Service Bulletin

SB No.FZ04071301N

Subject: FZBE Adjustment Pin Is Not Working Properly

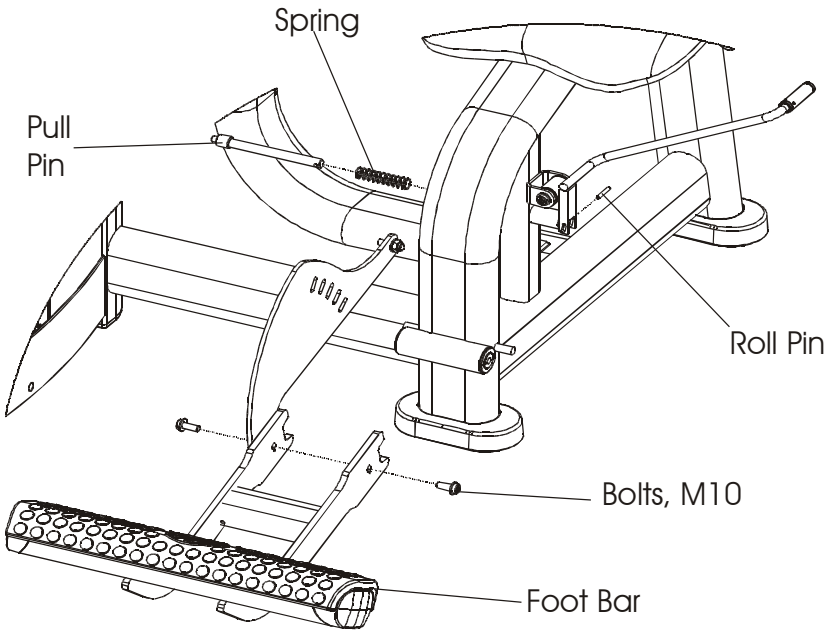
Adjustment pin is not working properly.

The following replacement parts are required:

1. 7748701 Spring
2. 3110011 Roll Pin
3. 7767101 Pull Pin

1. Disconnect the gas spring from foot-bar. Use flat screwdriver to release metal clip.
2. Using a hammer and center punch, drive the roll pin out of the small hole in the pull pin.
3. Loosen two M10 bolts from the foot-bar, and then remove the foot-bar.
4. Replace the pull pin and spring.
5. Re-assemble as before.
